ADDENDUM NO. 2

May 6, 2022

NEW ADMINISTRATION CENTER, ALTERNATE EDUCATION AND RESOURCE CENTER AND RELATED WORK PROJECT
Crown Point, IN 46307

ADDENDUM TWO

OVERALL MECHANICAL MAIN LEVEL FLOOR COMPOSITE PLAN

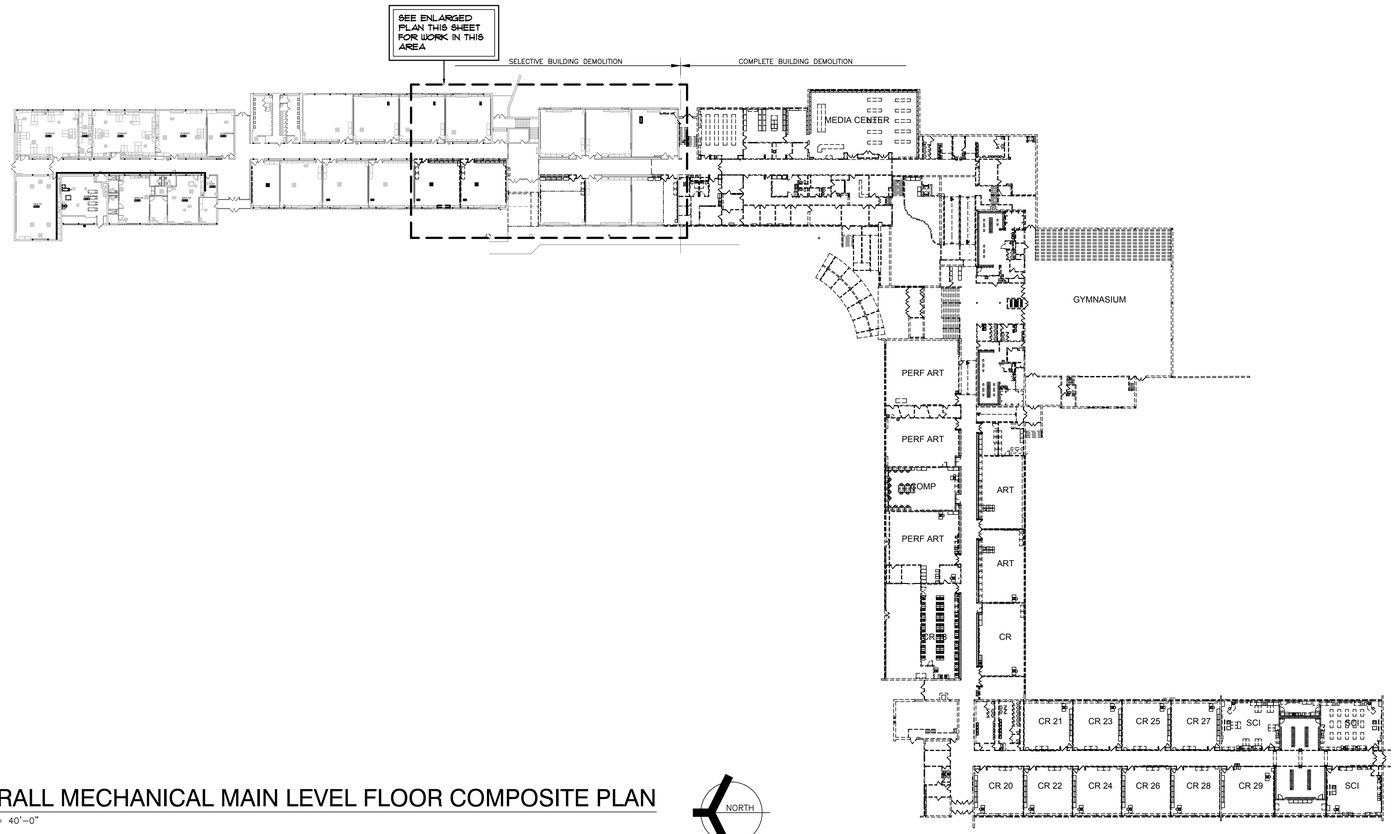
1. Revised note removing existing unit ventilator to abandoned existing unit ventilator.

1 MV101 **FIRST FLOOR MECHANICAL DUCTWORK PLAN**
1/8" = 1'-0"

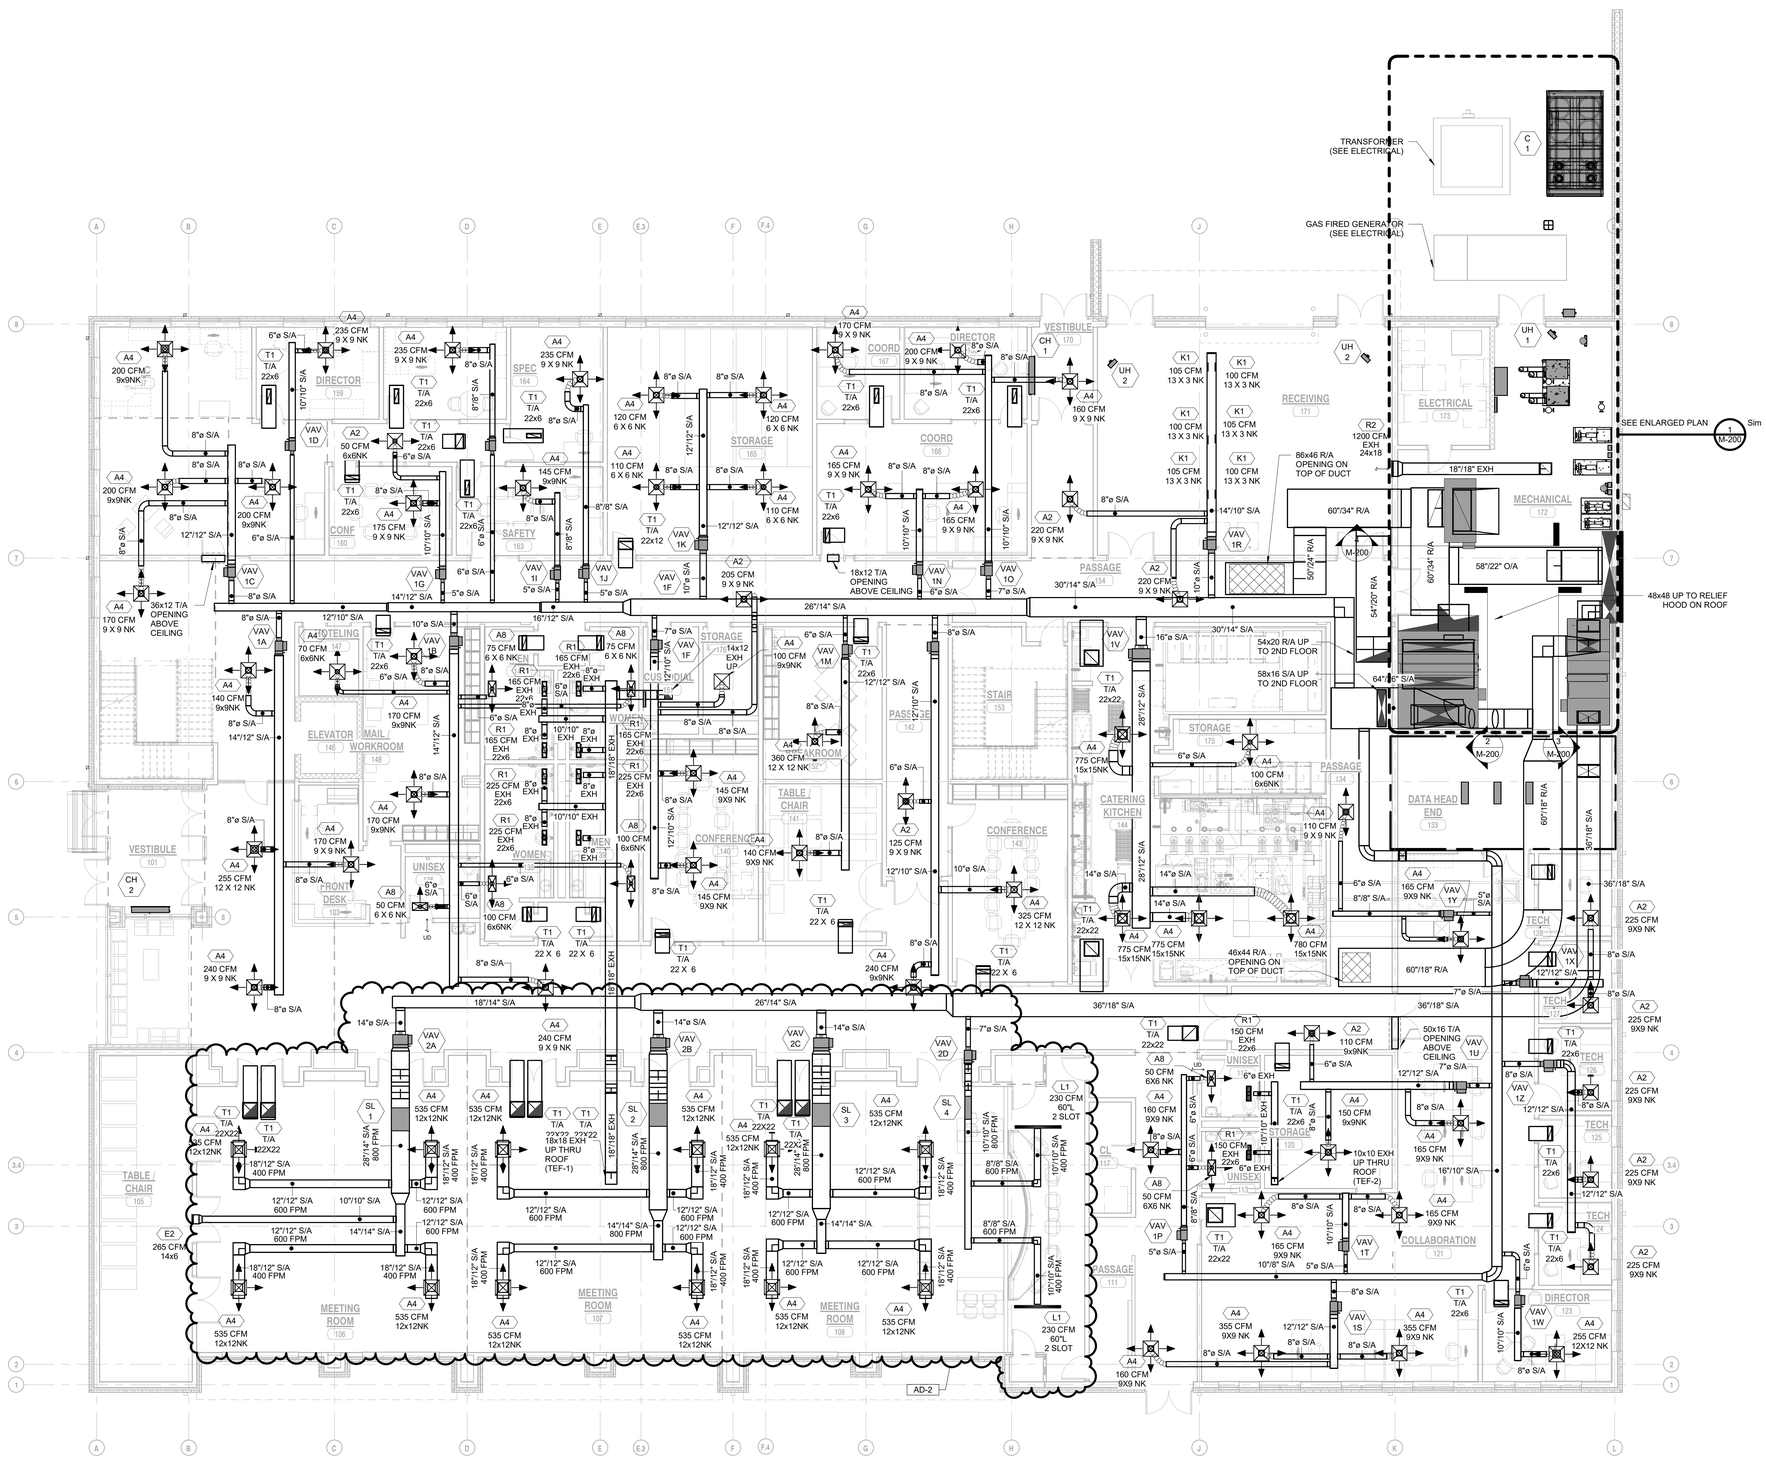
1. Revised meeting room ductwork.
2. Added silencers to VAV-2A, 2B, 2C, and 2D.

1 MV102 **SECOND FLOOR MECHANICAL DUCTWORK PLAN**
1/8" = 1'-0"

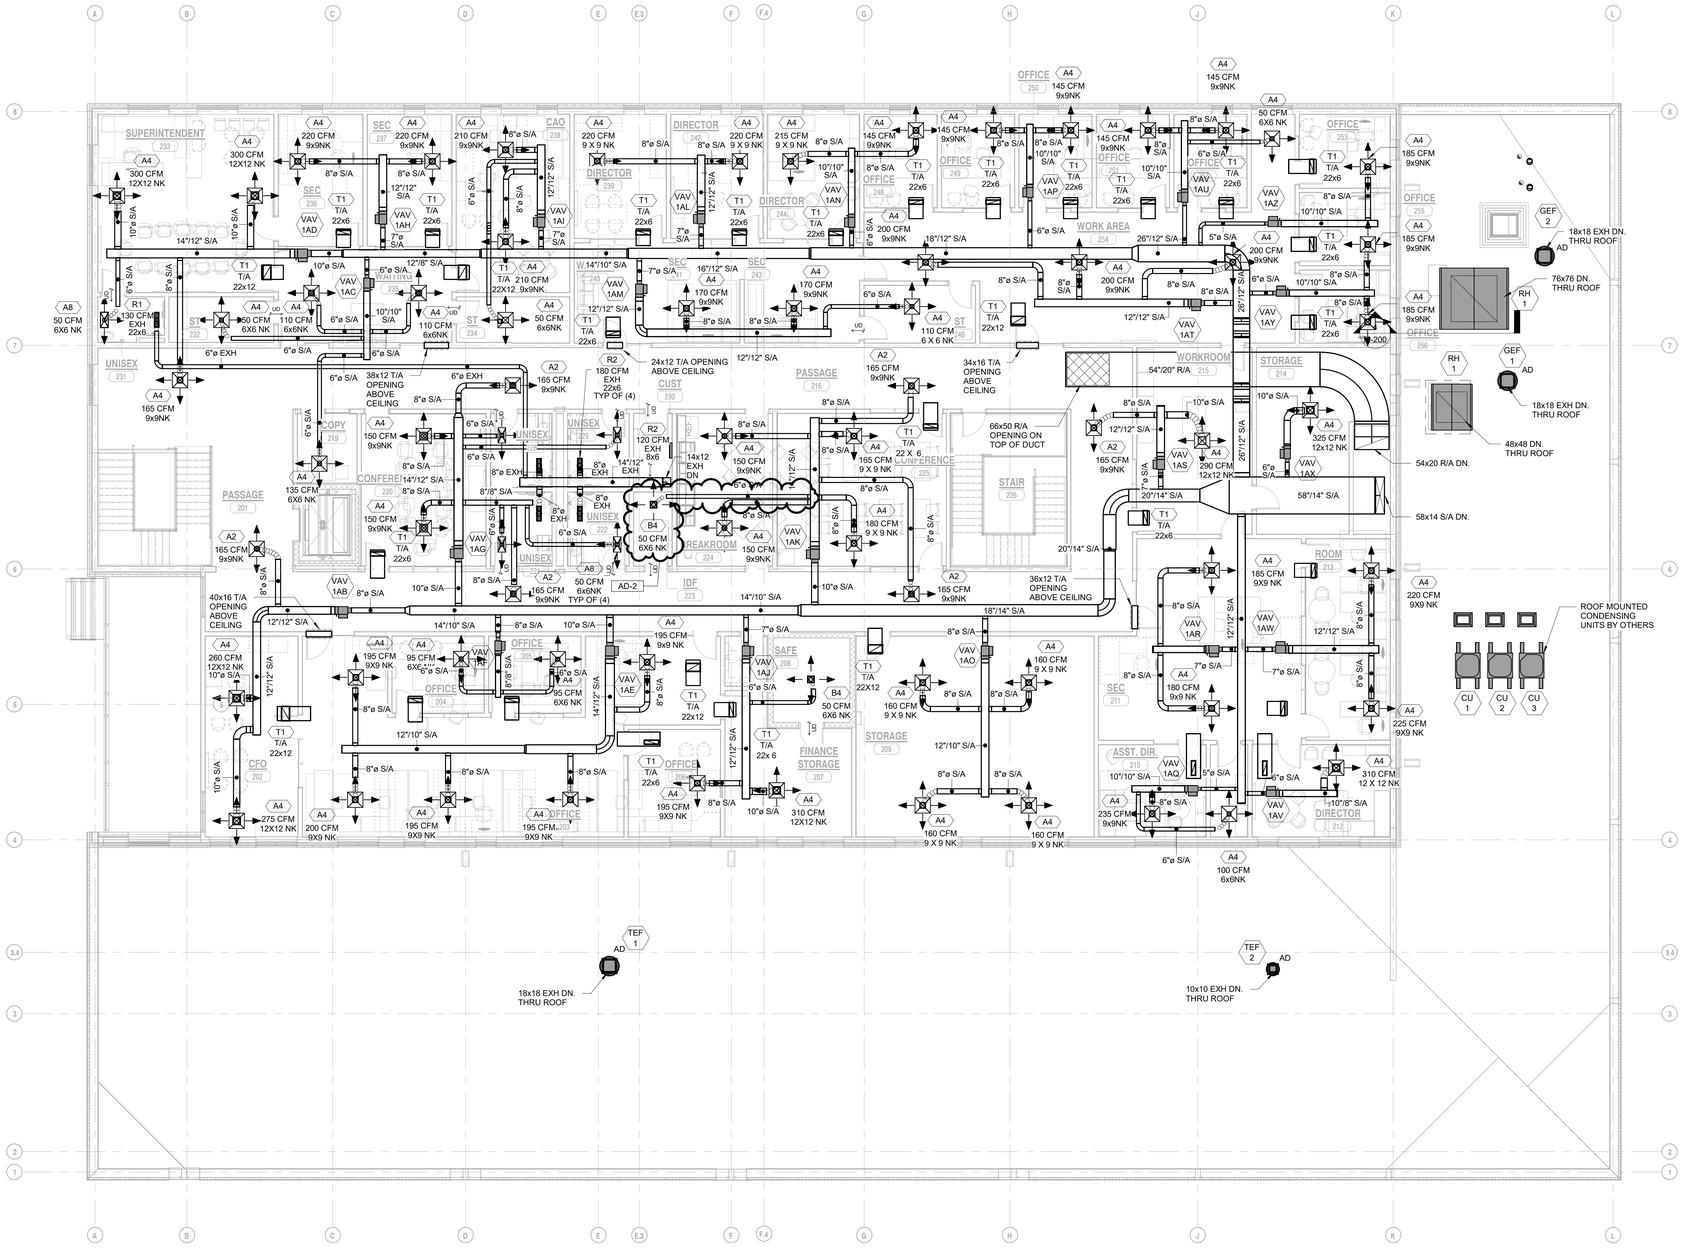
1. Added supply air to IDF 223.

MECHANICAL ROOF PLAN NORTH

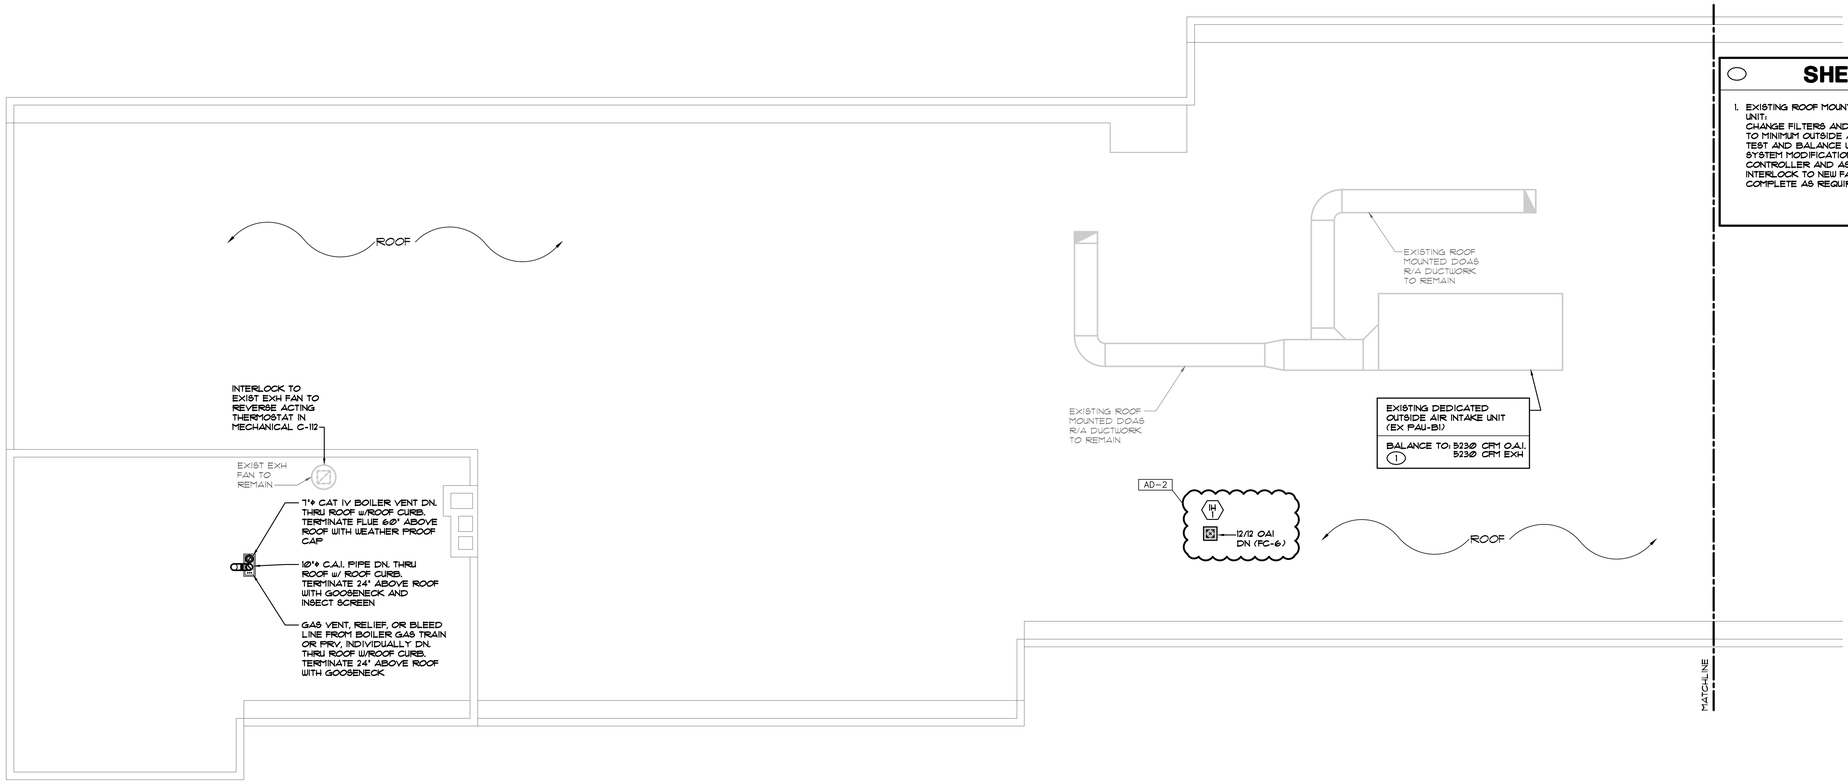
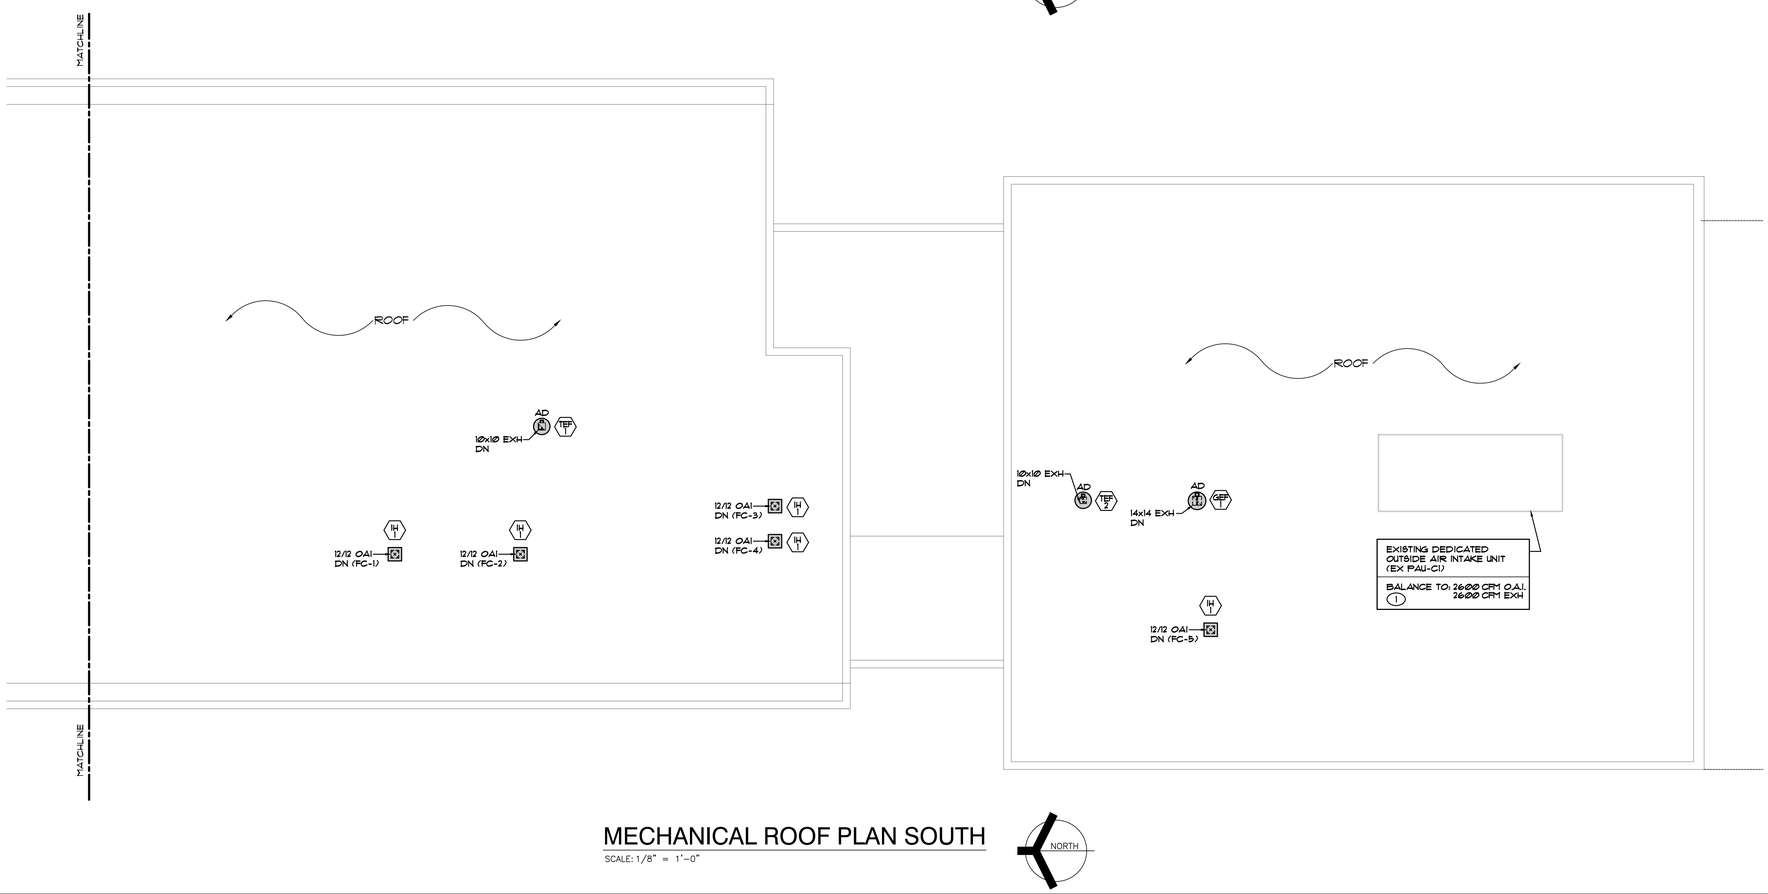
1. Added expansion compensators and anchors.
